City of Tacoma

**ADDENDUM NO. 2**

**DATE: 9/26/2023**

**Request for Bids Specification No. PW23-0027F  
Manitou Elementary Safe Routes to School**

D-1

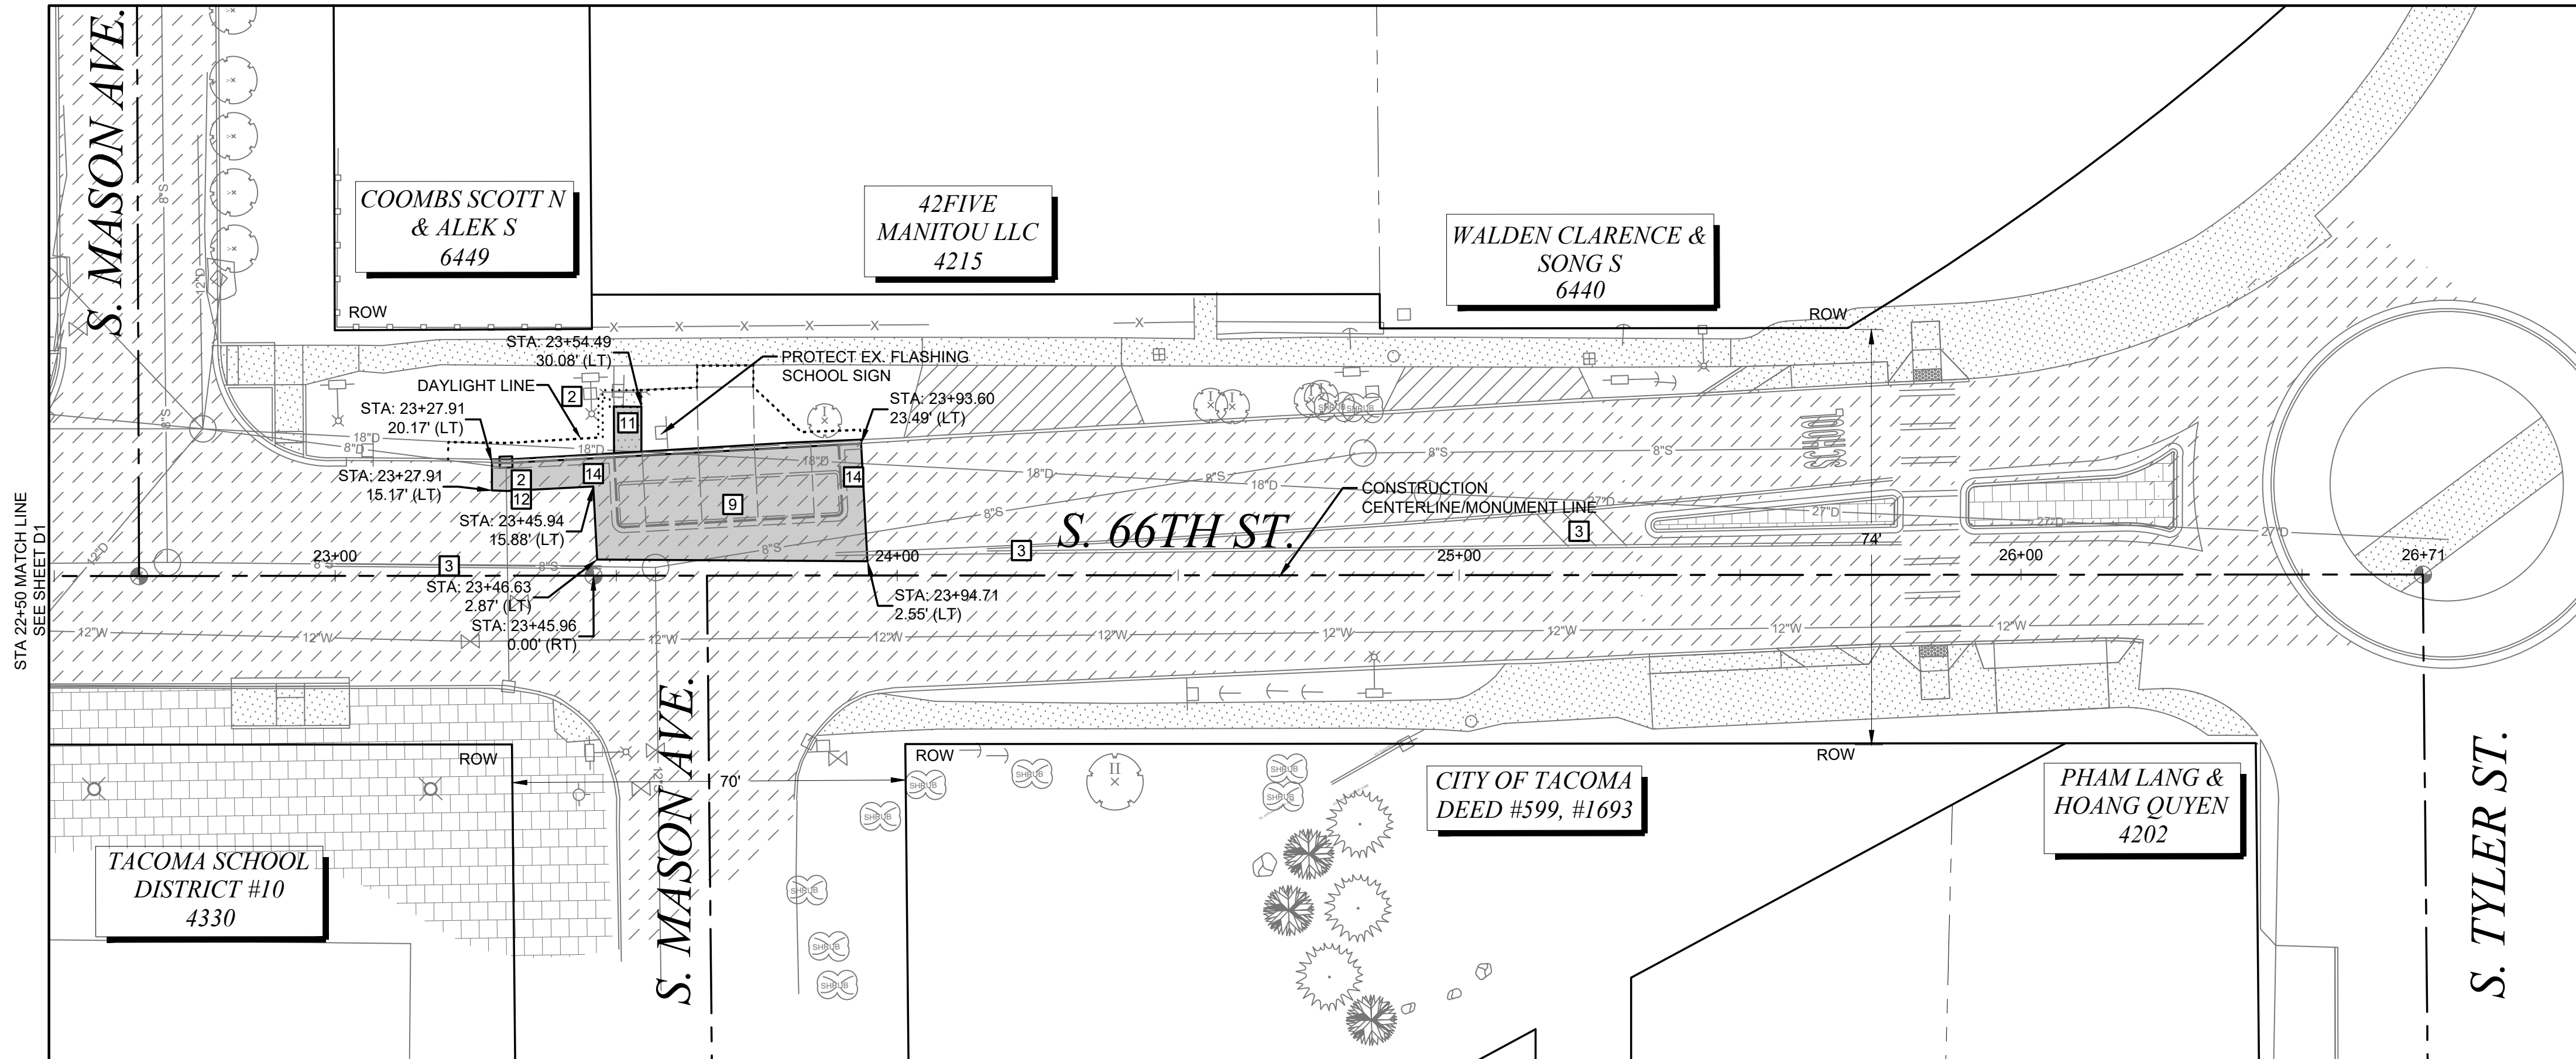
Remove Plan Sheet “D-1” and replace with Plan Sheet “D-1 Addendum 2”

RS-1

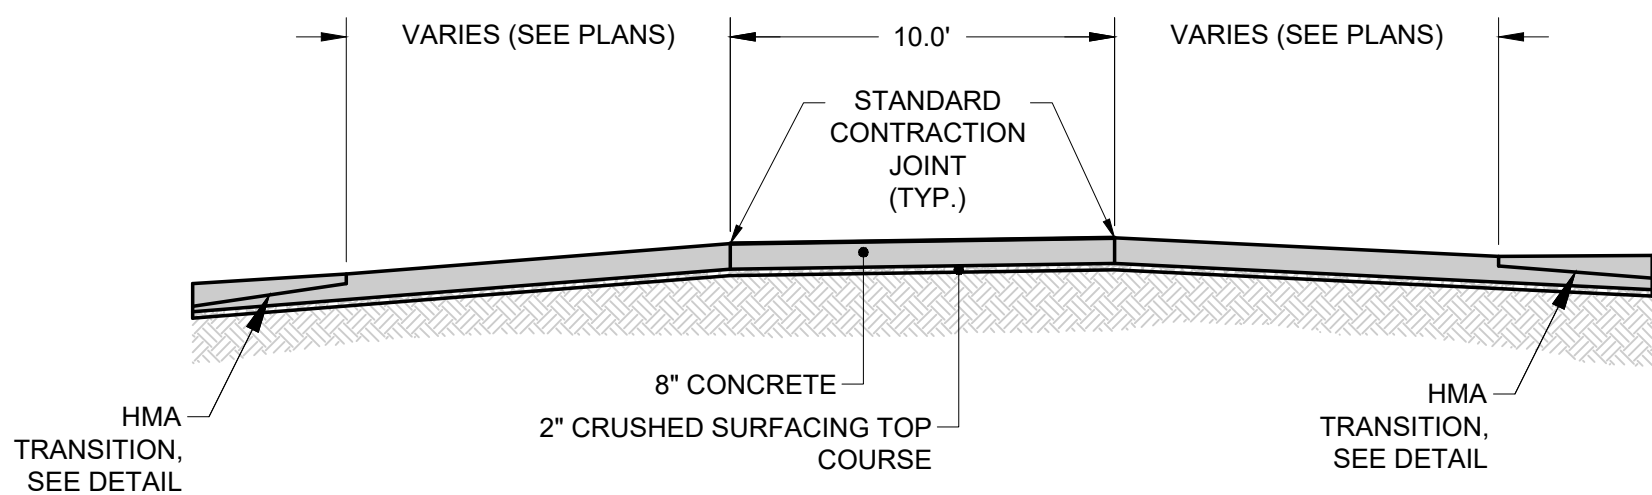
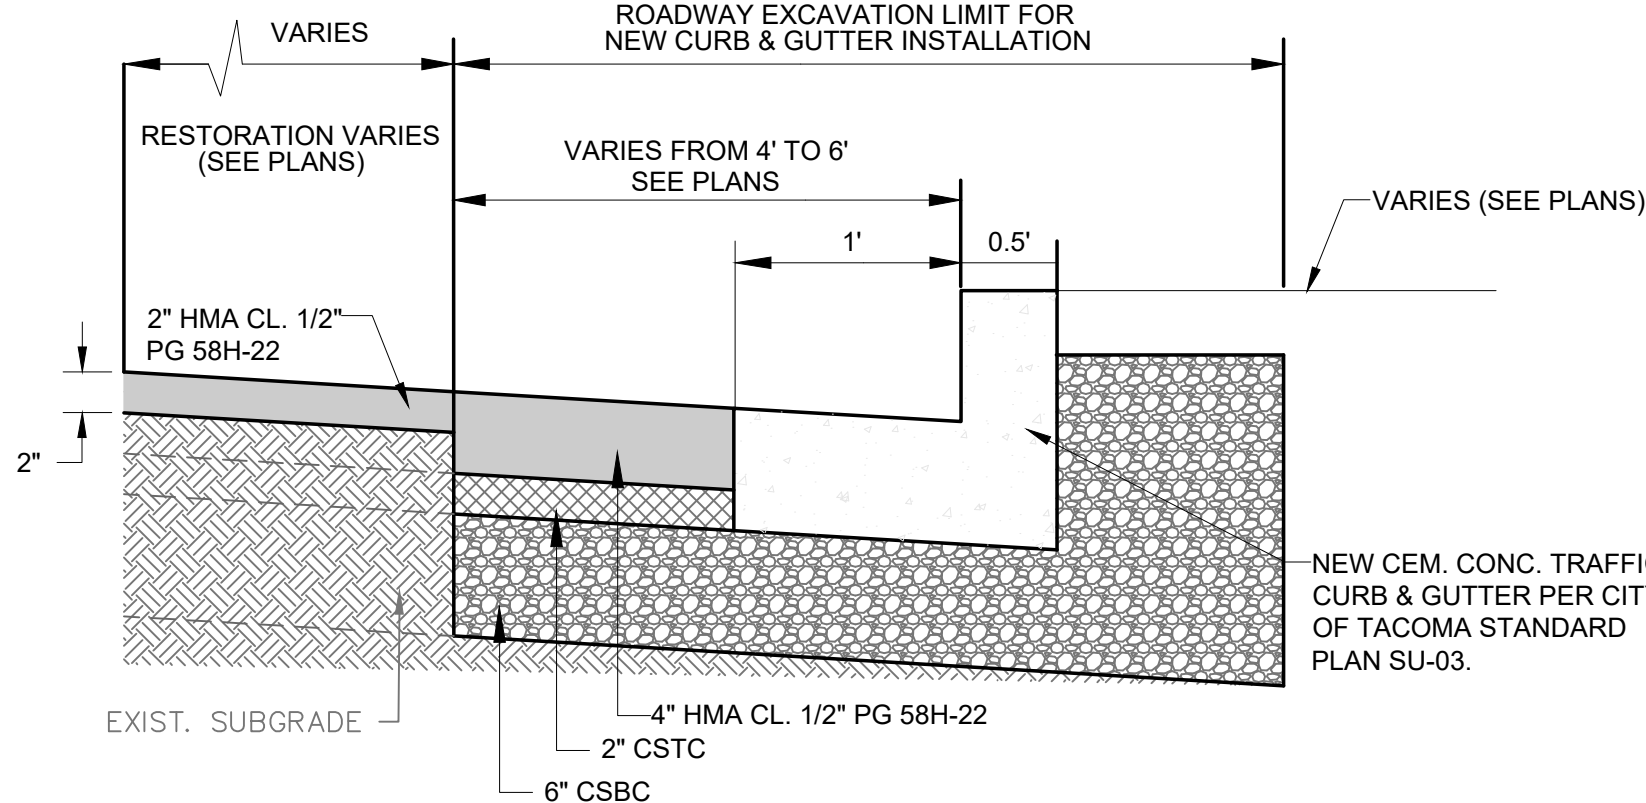
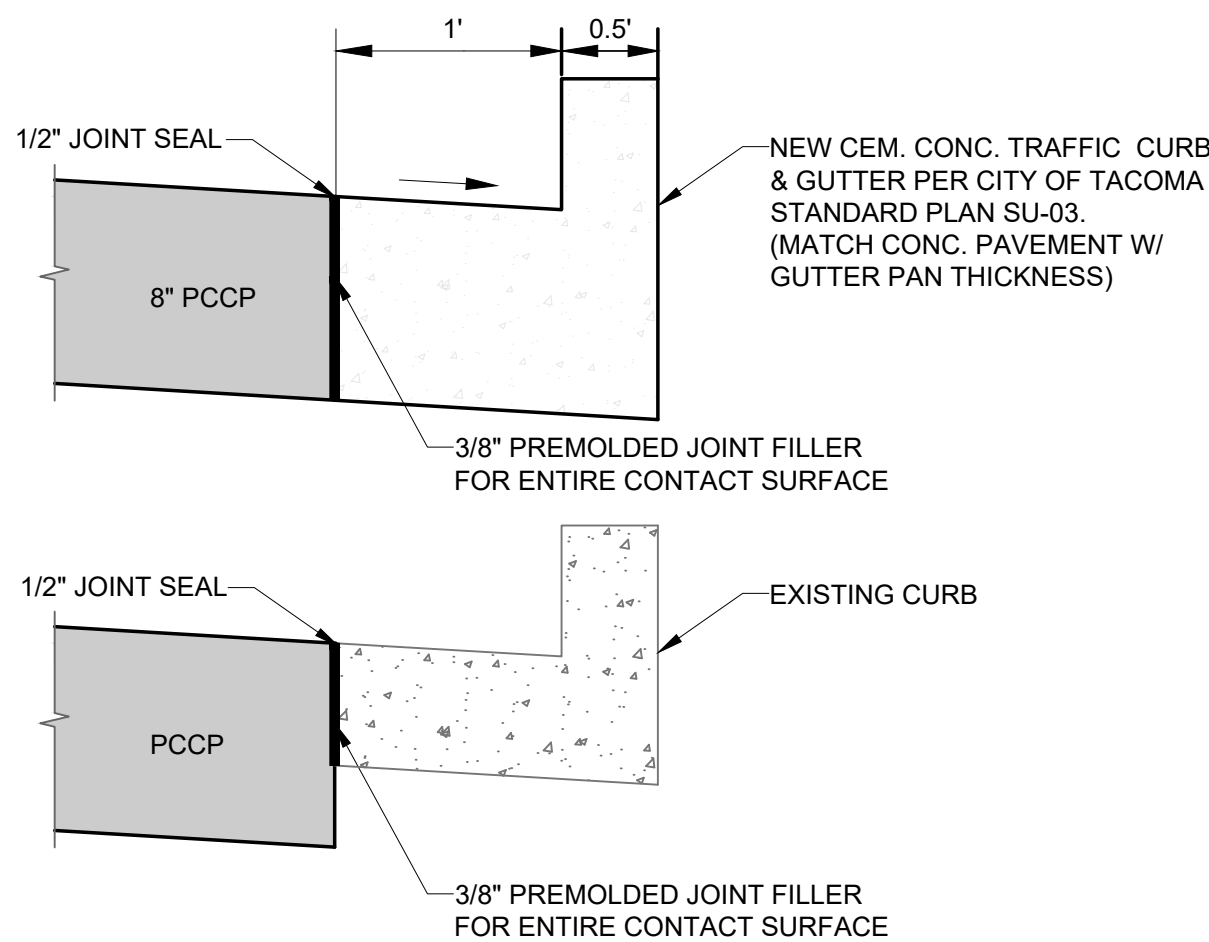
Remove Plan Sheet “RS-1” and replace with Plan Sheet “RS-1 Addendum 2”
